10/558,437

Soung Bong Choi

Office Action Summary	Application No. 10/558,437	Applicant(s) CHOI ET AL.	
	Examiner FRANKIE L. STINSON	Art Unit 1792

STODDARD'181

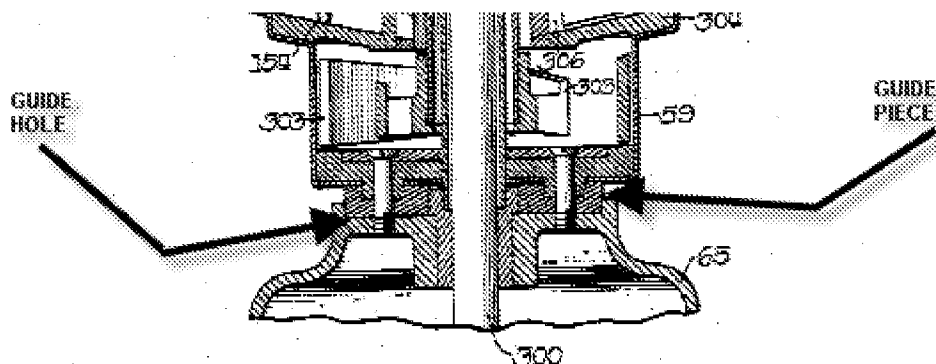
having a shaft hole, and a guide piece (17 in Brotz, see annotated fig. 5 below in Stoddard'181, see 44, in Stoddard'300 and 4 in Dort) projected outward; and

a motor (22 in Brotz, 65 in Stoddard'181, 134 in Stoddard'300 and 5 in Dort) for generating pumping force to pump the washing water from the sump to the tub, the motor having a guide hole (page 1, right col. lines 91-92 in Brotz, see annotated fig. 5 below in Stoddard'181, see 150 in Stoddard'300 and see 8, 9 in Dort) for receiving the guide piece on the sump.
